**CITY OF LA VISTA
MAYOR AND CITY COUNCIL REPORT
AUGUST 20, 2024 AGENDA**

Subject:	Type:	Submitted By:
CONDITIONAL USE PERMIT – BEAR CREEK APARTMENTS	◆ RESOLUTION ORDINANCE RECEIVE/FILE	CALE BRODERSEN ASSOCIATE CITY PLANNER

**CITY OF LA VISTA
PLANNING DIVISION
RECOMMENDATION REPORT**

CASE NUMBERS: PPUD23-0006; PCUP23-0010; PRP23-0004

UD Site Plan

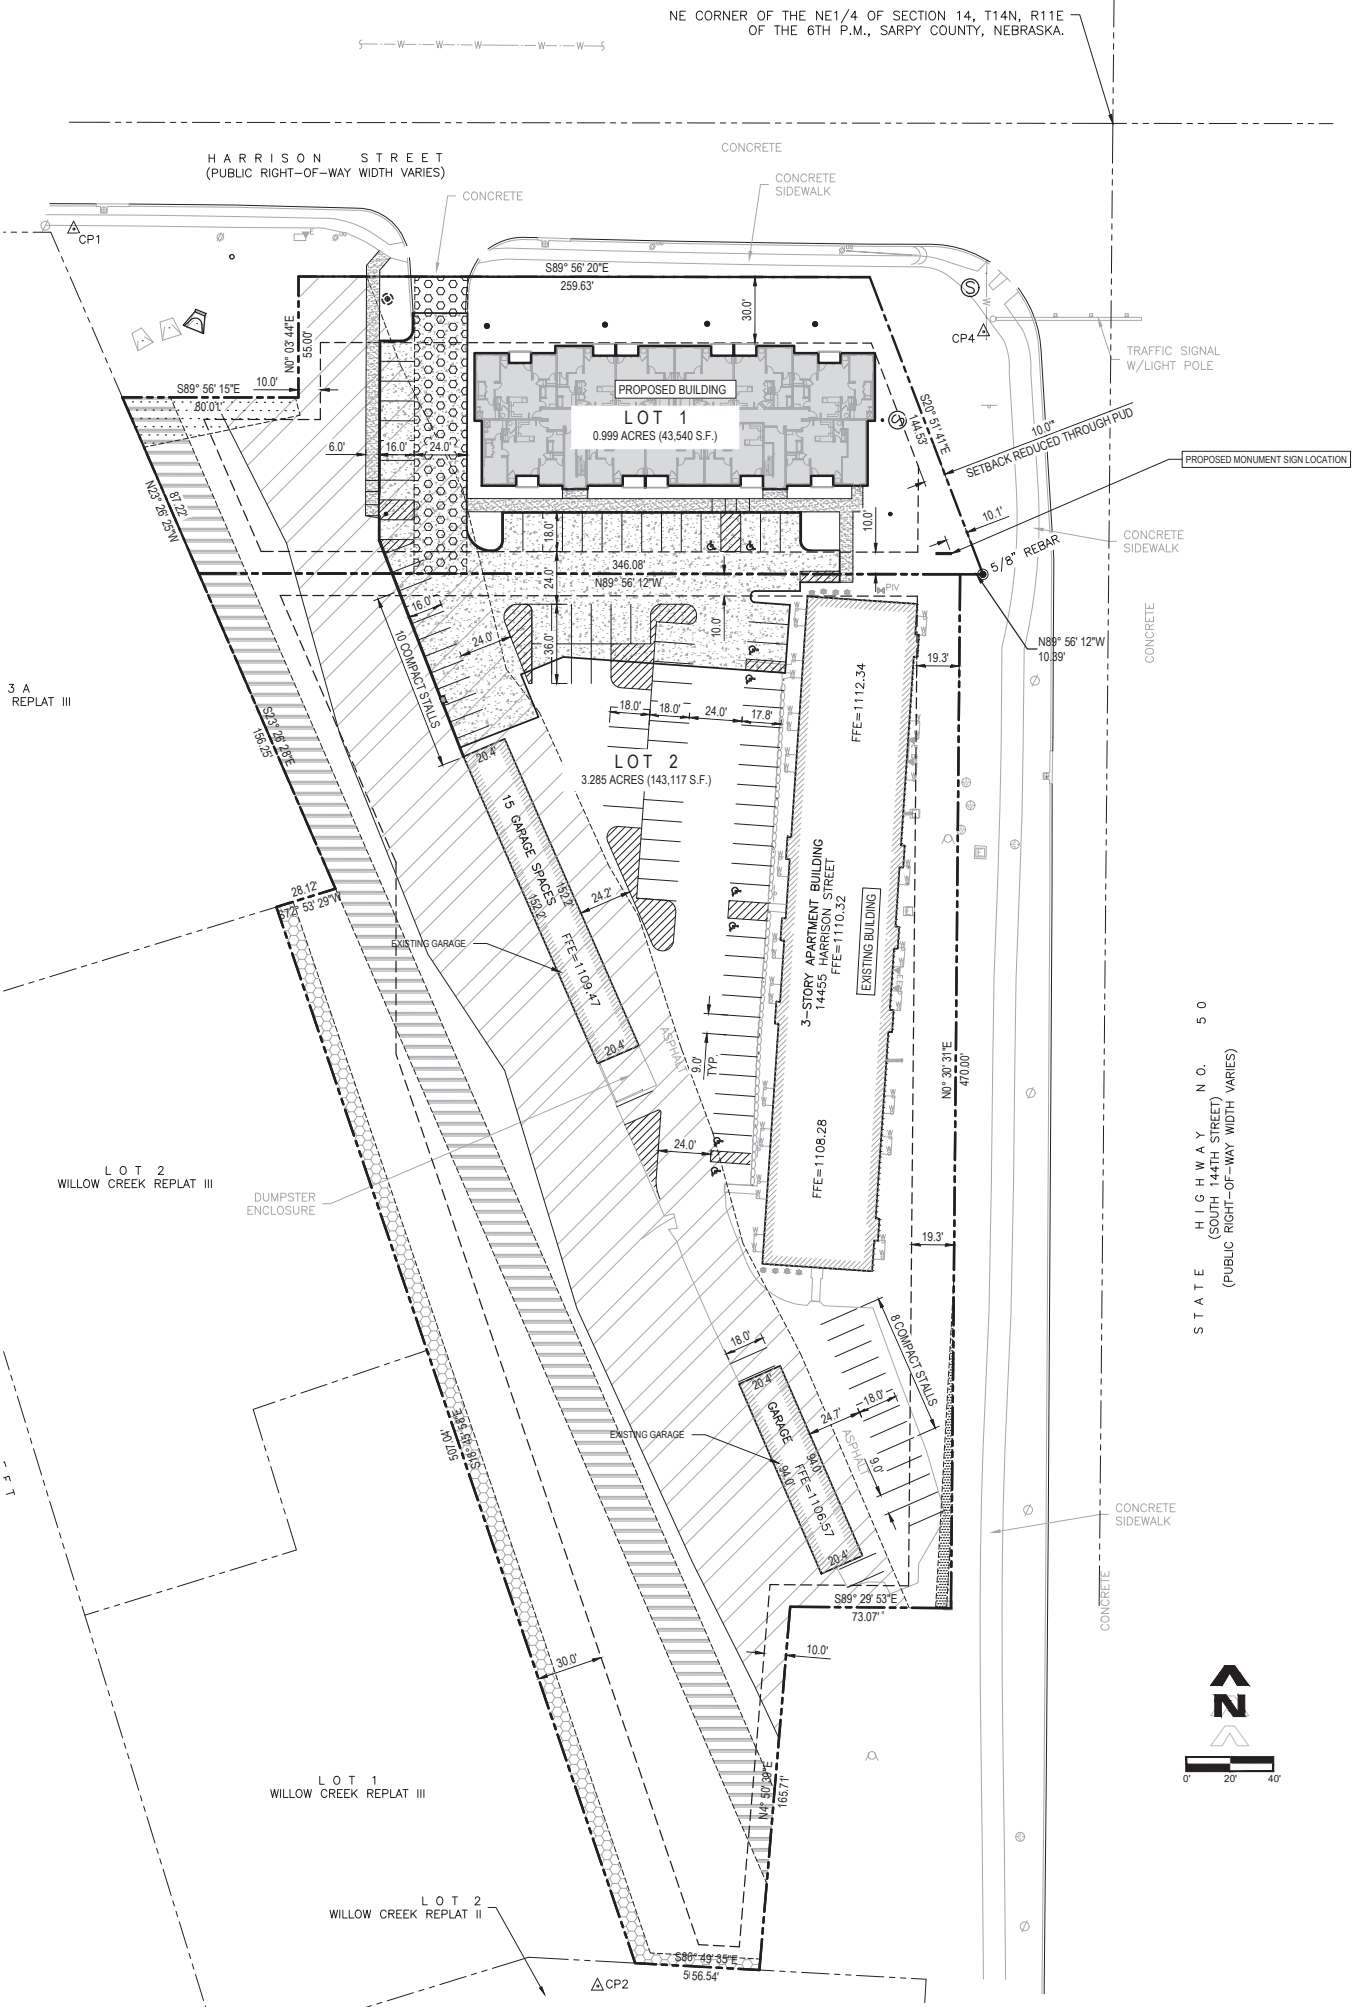
9. Please include the dimensions for the north side yard setback for the existing building on proposed lot 2 in the PUD plan set.
Setback dimensions have been added to the Site Plan.

10. Where you are requesting reduced setbacks through the PUD (i.e. the reduced front yard setbacks along 144th Street, and the reduced north side yard setback for the building on proposed Lot 2), please add a note stating setback reduced through PUD" on the PUD site plan.
Setback reduction notes added to the Site Plan.

11. Regarding Section 5.15.05.03.06, please provide dimensions of the off-street parking, inclusive of alley widths.
Dimensions have been added to the PUD Site Plan.

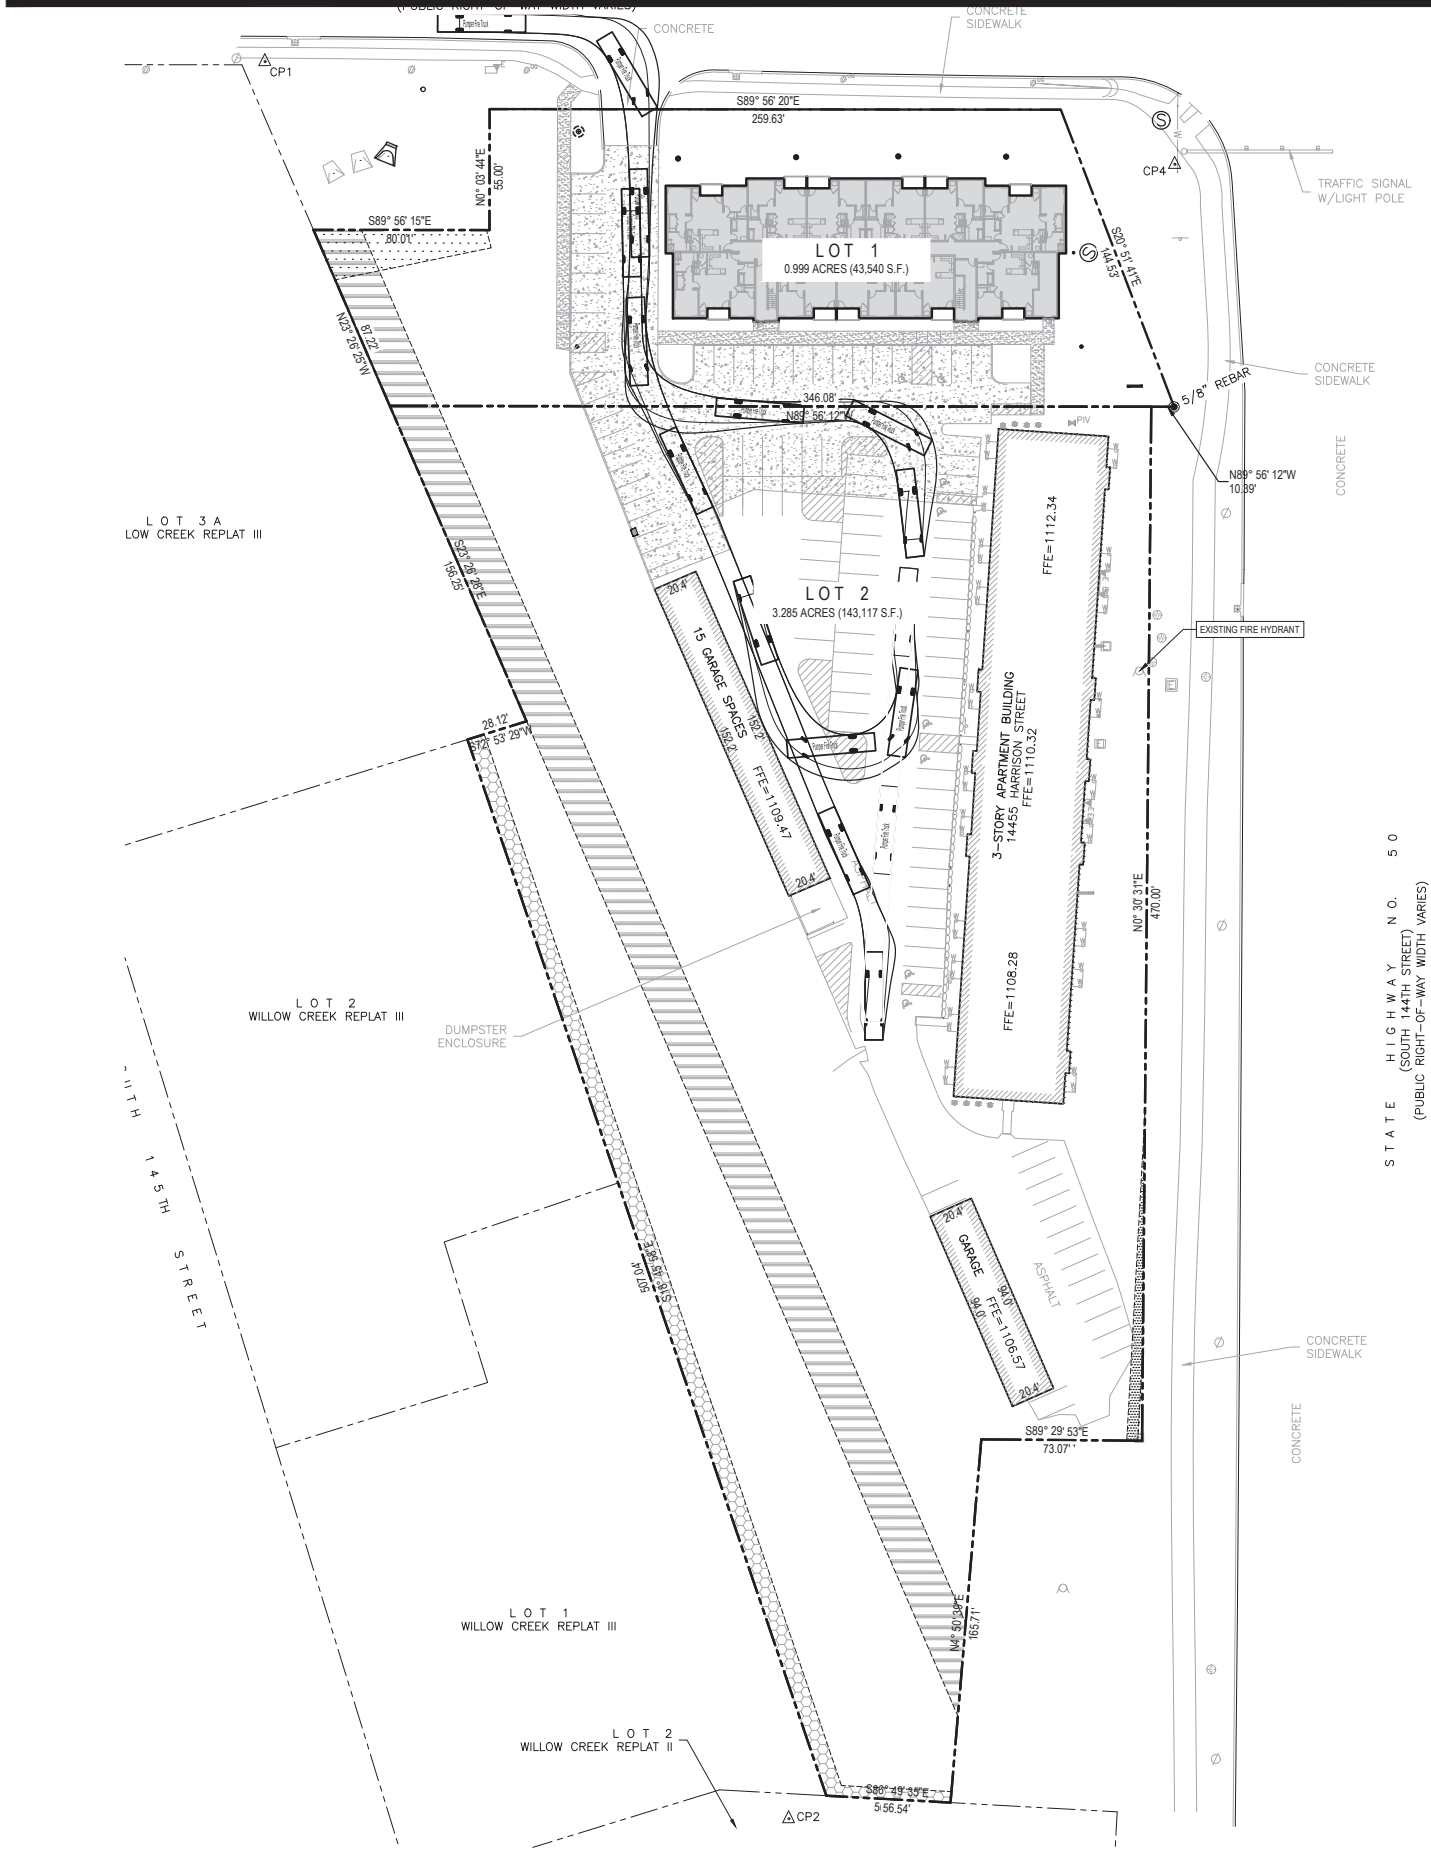
1. Landscaping
 - i. Per 4.III.D.2, a minimum of one species of deciduous shrub is required, none are included in the plant schedule.
 - ii. Irrigation required per 4.III.G not indicated on plans.

Recommend additional landscaping between buildings, parking lots and drive lanes to soften the transition between pavement and the buildings. This could include plantings from Appendix G.

Recommend landscape along Harrison Street and 144th Street which includes elements from Appendices B and C from the Architectural and Site Design Guidelines for the Southport Development. These items include but are not limited to berms, street trees, shrubs and other low plantings.

1. Please find attached as Exhibit A the initial review letter from the City's third-party design review architect regarding changes required for the property come into compliance with the Gateway Corridor Overlay District's landscaping requirements. Please make the necessary changes to the landscaping plan, inclusive of irrigation for the landscaping areas along Harrison Street and S. 144th Street and resubmit to the City for further review.
Bobo Hydrangea have been added to the planting schedule and are shown along the retaining wall on the north side of the proposed apartment building. Note no. 4 has been added to the Landscaping Notes stating that all proposed landscaped areas shall receive irrigation, including landscaping along 144th & Harrison Street.

2. Beyond the changes referred in comment #1 above that are required to satisfy the requirements of the Gateway Corridor Overlay District, as a condition for the use of the Planned Unit Development tool to reduce the required front yard setbacks along S. 144th Street, additional landscaping areas shall be provided in accordance with the letter from the City's third-party design review architect attached as Exhibit B.
Additional shrubs have been added between the parking lot and building as outlined in Exhibit B, as well as additional shrubs along the north retaining wall. A smaller, more ornamental tree has been added to the planting schedule along 144th & Harrison Street as outlined in Appendices B and C of the Southridge Design Guidelines. The selected tree, Downey Hawthorne, is identified in Appendix G of the Southridge Design Guidelines and is intermixed with the overstory trees along 144th & Harrison Street.

PUD Fire Access
Plan

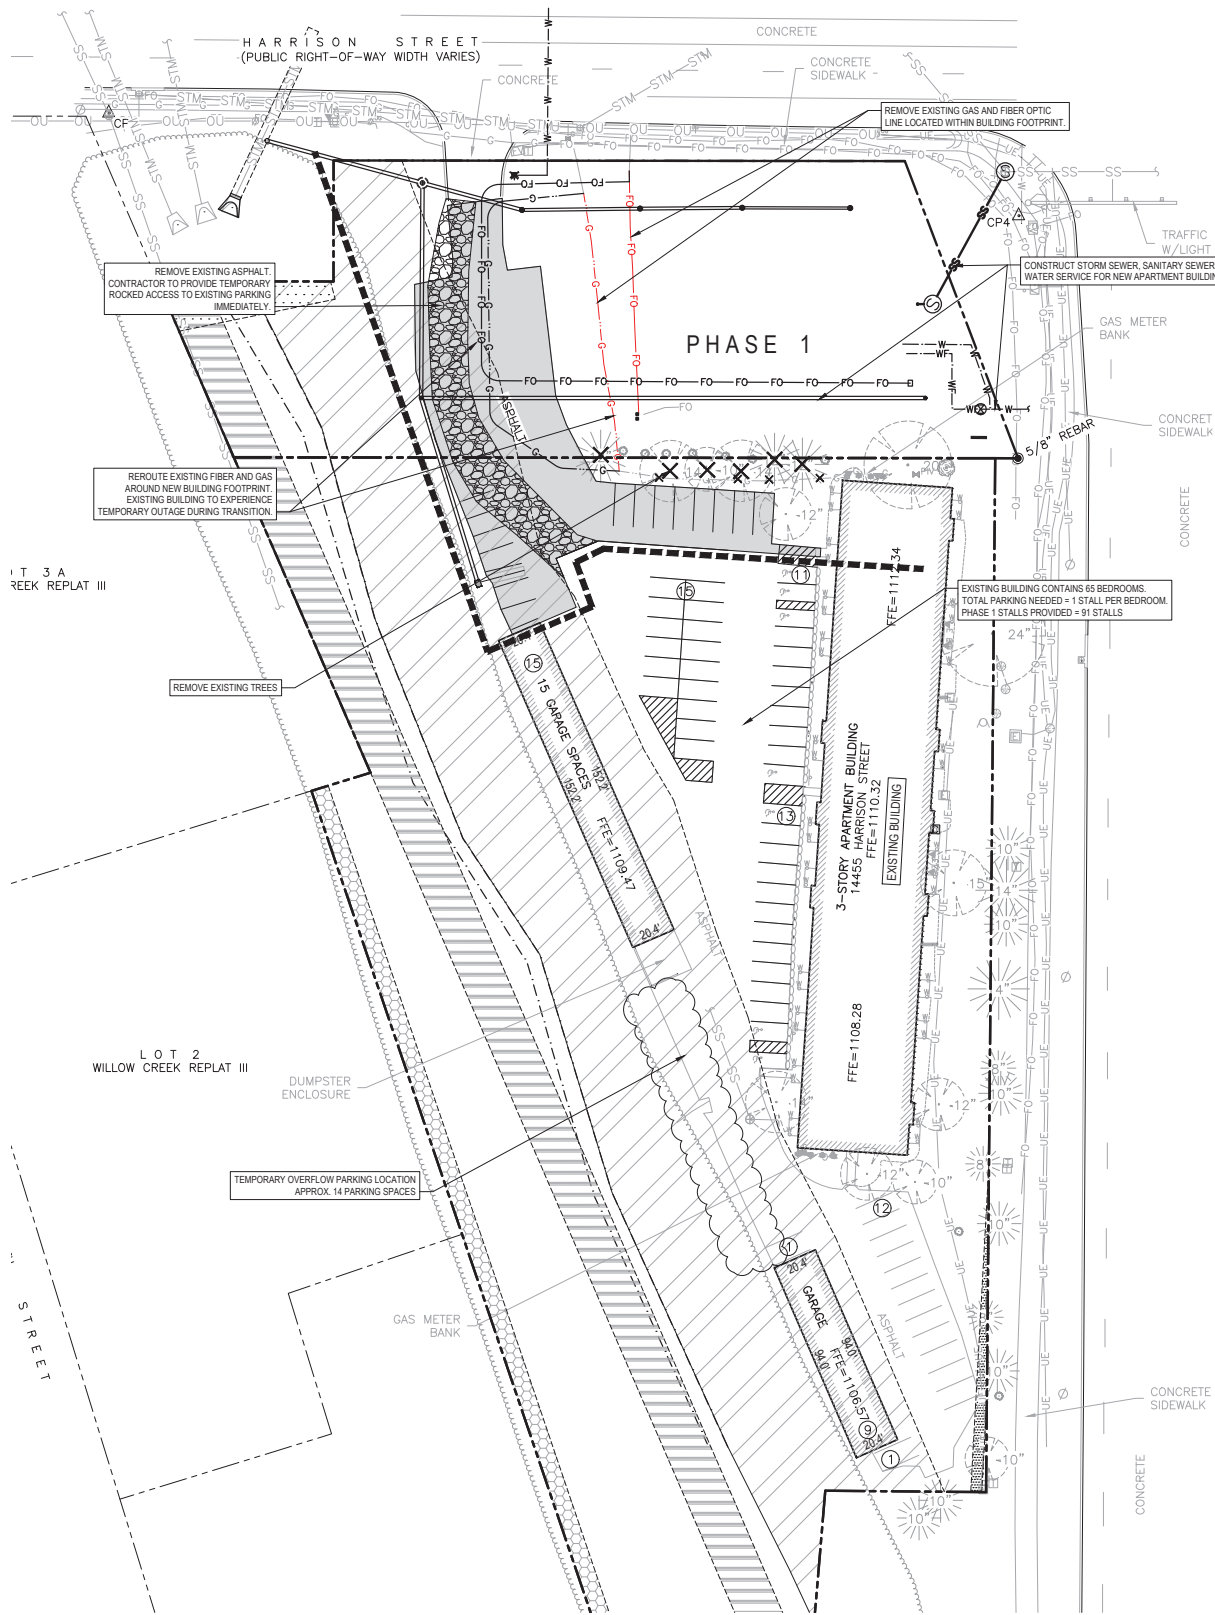
4. Due to the singular driveway access point to the Bear Creek Apartment complex, the Fire Inspector with the Papillion Fire Department has noted concerns regarding the ability for first responders to respond to emergencies at the existing and proposed new apartment buildings. Subsequently, they have noted requirements to upgrade the fire protection engineering system of the upcoming structure and construct an additional fire hydrant. Please find e-mail correspondence from the Papillion Fire Inspector attached as Exhibit D, and adjust the plans as necessary to comply with the requirements.

In response to paragraph 4, concerning the fire inspector response, the applicant has received Nicholas Gunia's email dated May 6, 2024 and is in the process of obtaining a cost estimate for the installation of the fire hydrant near the corner of the entry of the complex. Once the applicant has this, it can then respond to the Gunia May 6, 2024 email. We should have this shortly. In the meantime, we would like to move forward to the planning board on the condition that the applicant will address the fire inspector's concerns prior to the CUP, PUD and replat being presented to the City Council for approval. I discussed this with Bruce Fountain previously, and Bruce was agreeable to proceeding in this manner.

PUD Phasing Plan

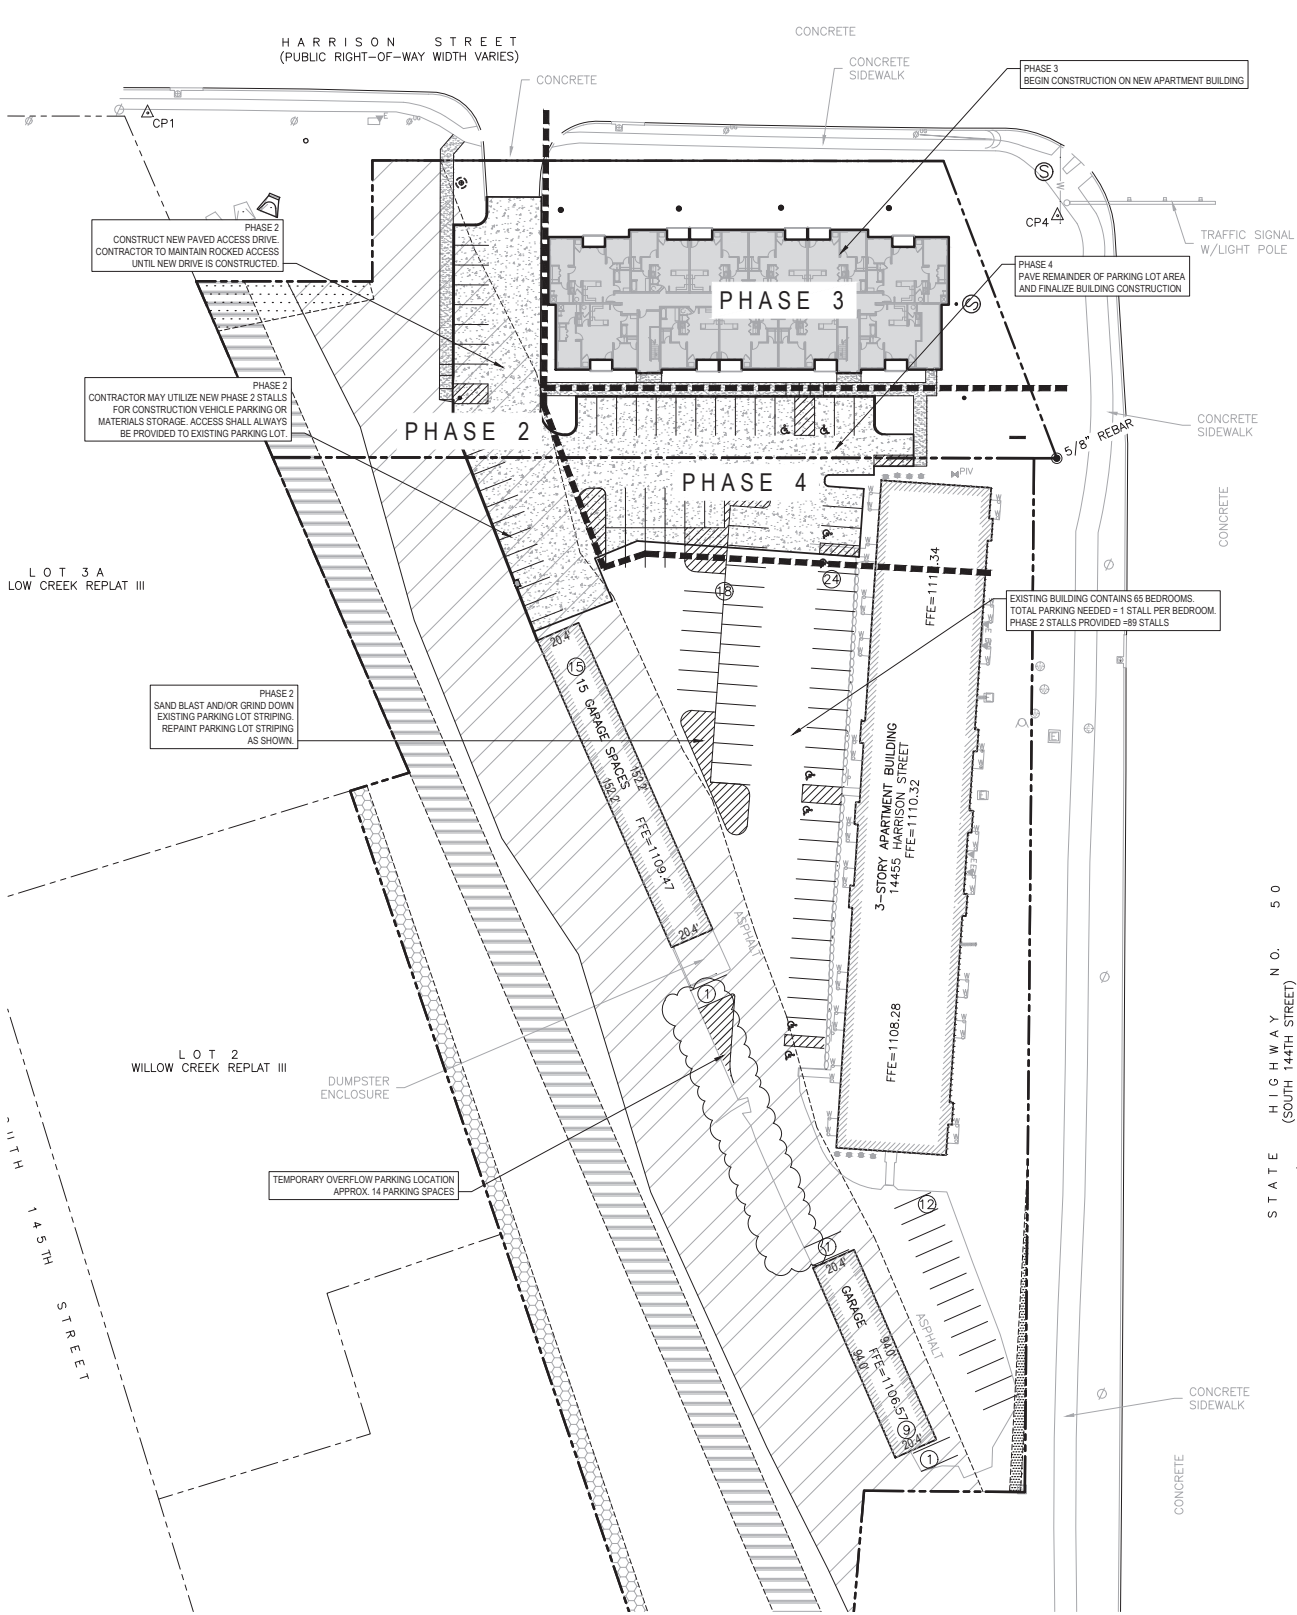
2. Regarding Section 5.15.04.04, please provide a staging plan and/or phasing exhibit to ensure that ingress and egress/access, and adequate parking counts are able to be maintained, and that all utilities/current services can still be provided to the residences in Lot 2, during the construction on Lot 1.
A proposed phasing plan has been included in this resubmittal. The contractor shall provide a rocked/gravel access path until the paved drive is reconstructed. There will be a brief interruption to the gas and fiber optic service during the transition to the rerouted lines.
